DATE: APRIL 2, 2014

FROM: HISTORIC PRESERVATION STAFF

SUBJECT: 711 PRINCE STREET,  
BAR CASE # 2014-0018 & 2014-0019

**ISSUE:** Partial Demolition/Capsulation and Addition

Figure 1. View of the northwest corner of the existing building from South Columbus Street

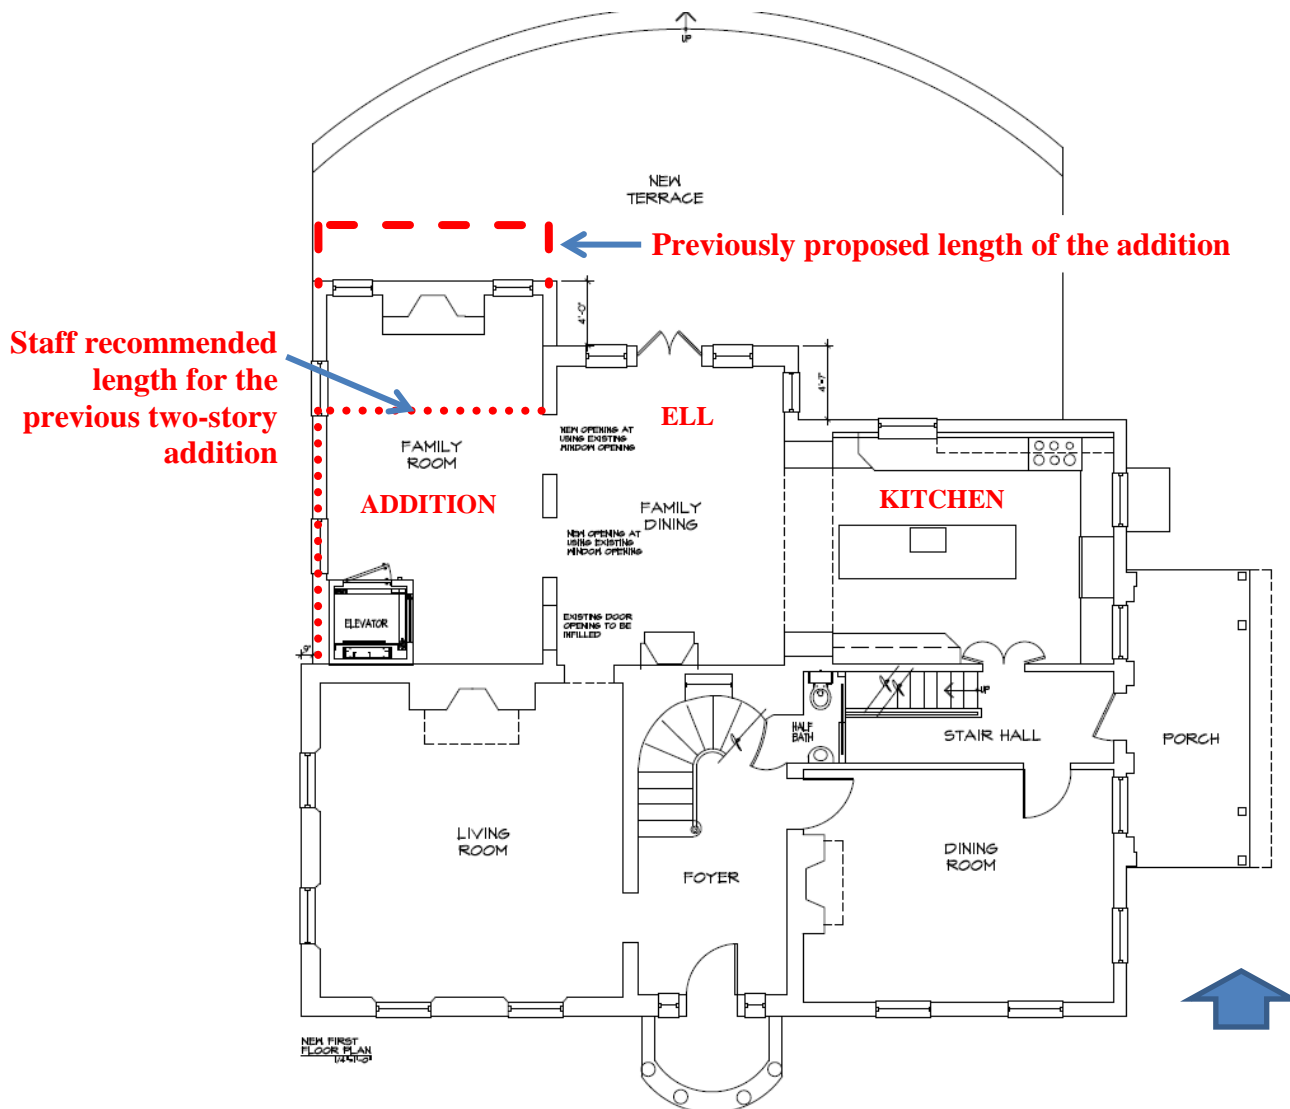
Although reduced from the original proposal, staff still has some reservations about the extent of the footprint of the first floor of the addition. The two story ell shown in the previous report extended 7'-6" north of the historic center ell. In that report, staff suggested a footprint for the addition that was recessed approximately 4'-6" south of the north wall of the center ell, to align with the north wall of the flounder on the other side of the ell, insuring that the mass of the addition was clearly secondary to the historic portions of the house. The revised application is now pulled back to 4'-0" north of the ell. While staff still prefers a smaller addition, the present single story proposal has significantly less adverse effect on the adjacent two story ell and can be supported in the overall scheme. As shown in Figure #1 below, a one story addition will still be visible but will obscure much less of the original building from South Columbus than the previous proposal.

Figure 3. The applicant's revised second floor plan with staff recommendation for a reduced addition to accommodate an elevator with a door on the east side.

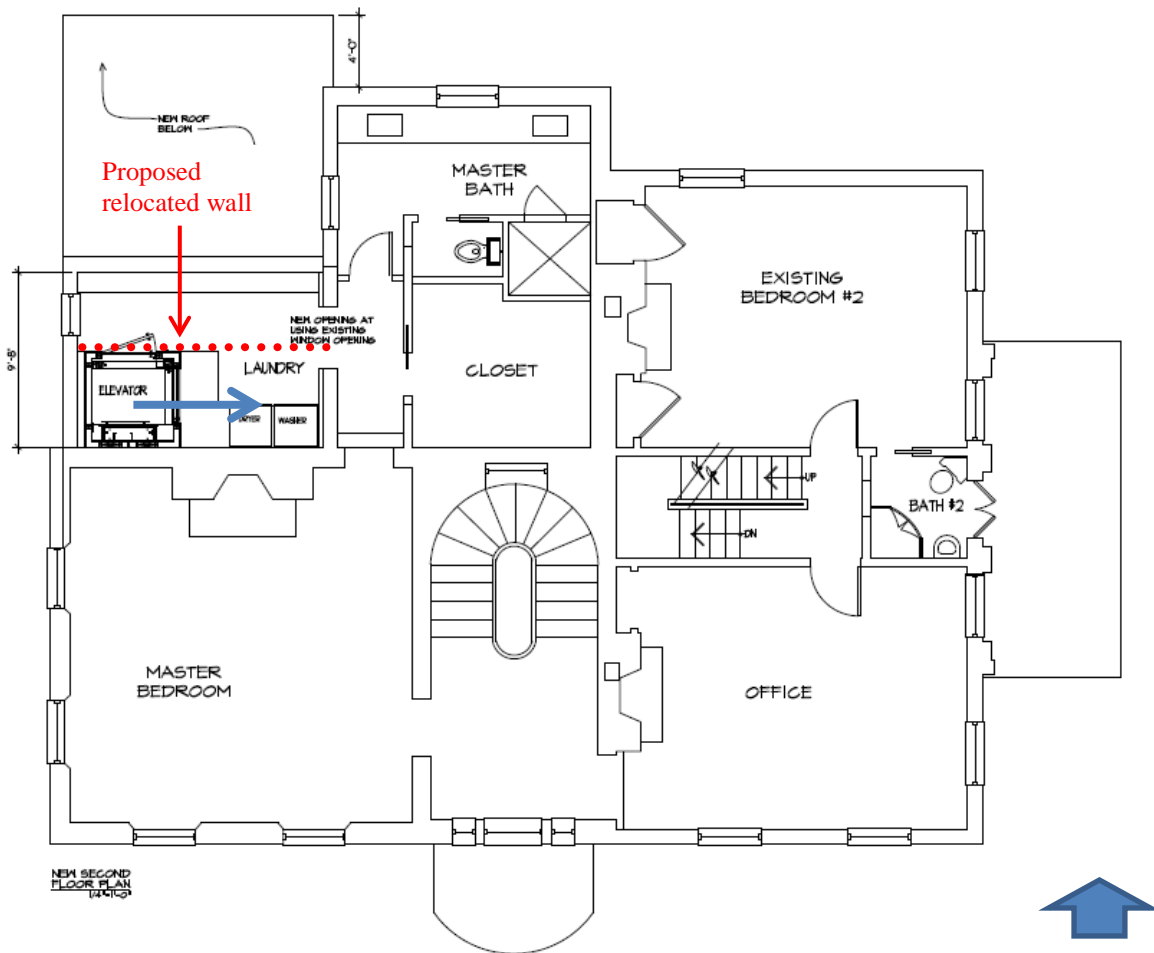
A second option, shown in Figure #3 below, is a simple shed roof addition that might recall a small enclosed sleeping porch, extending approximately six feet from the north wall of the historic building. The elevator cab could have two doors, as it did in the previous submission, so that the cab could exit to the east on the second floor, or the door could be located on the east side of the cab on all floors. This alternative eliminates the small window on the west elevation of the enclosure. It also requires the existing second floor masonry window (shown on the plans as a door) opening in the center ell to shift south a few feet. The door and window openings are irregular on the west façade of the ell and appear to have been altered in the past. This is the alternative suggested by staff, as it significantly reduces the mass of the second floor addition as viewed from Prince Street (see Figure #4 below).

At a minimum, the present elevator enclosure extension could be reduced another foot and lose only what appears to be shelving on the north wall. This version of the enclosure would extend north approximately nine feet overall and would still allow room for a generous laundry. Staff notes that the width of the second floor enclosure shown on the applicant's New West Side Elevation drawing scales approximately 11'-4" while the plan indicates only 10'-4", so another foot narrower than this plan dimension indicates would further improve the proportions.

2. Reduce the footprint of the elevator enclosure at the second floor to extend no more than 6'-6" north of the historic structure.
3. All windows, doors and materials must comply with the Board's adopted policies and be approved by staff, in conjunction with approval of a building permit.

Figure 7. Suggested reduced floor plan area for a one story addition.

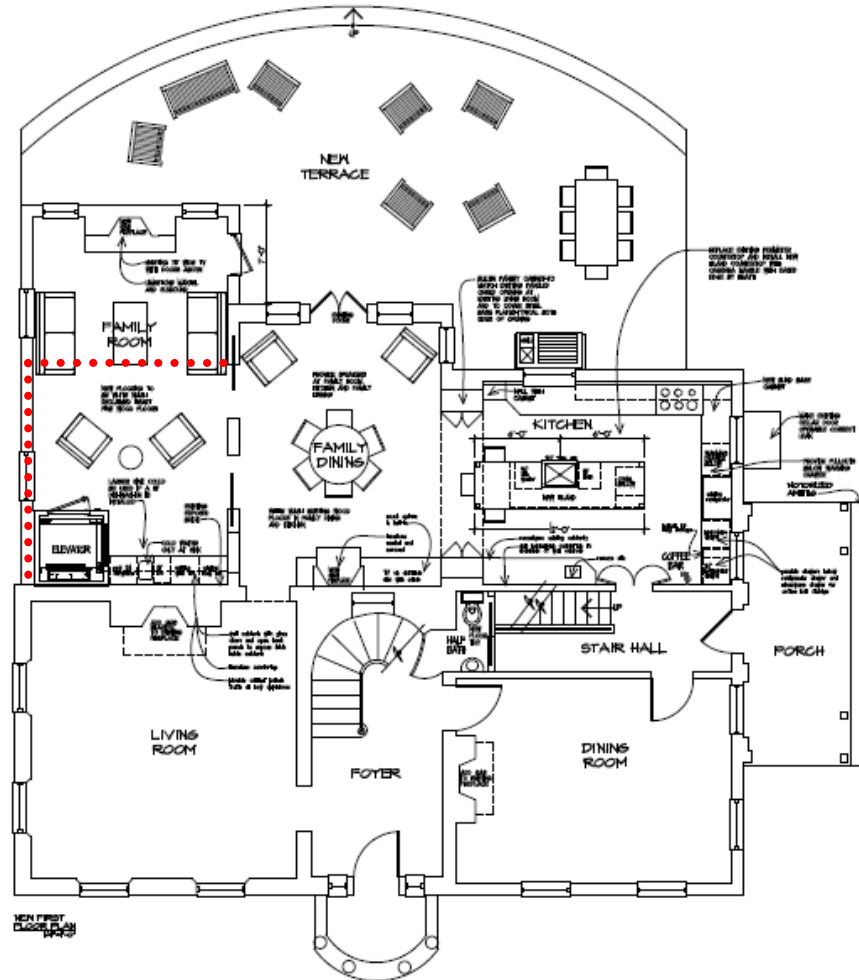
However, should the Board agree to the applicant's request for some additional building area, a well-designed and sensitive one-story addition may be acceptable. Staff's first preference would be for a distinctly separate folly or garden conservatory addition extending north of the existing ell, so that it would not touch the main building mass. Alternatively, a much smaller addition to the west of the existing ell, with minimal visual impact above the first story, would be preferable to the present proposal.

A reduced addition should extend no higher than the bottom slope of the roof of the existing rear ell and be set well back from the north wall of the ell. This would significantly reduce the visual impact of an addition from both Prince and South Columbus streets and minimize the physical impact on historic fabric, preserving the view of the unusual triangular wall siding above. Alternative space should be available for the presently proposed second floor function. Staff has suggested an elevation and plan outline of a single story addition with a reduced footprint for the Board's consideration in Figures 5 and 6.
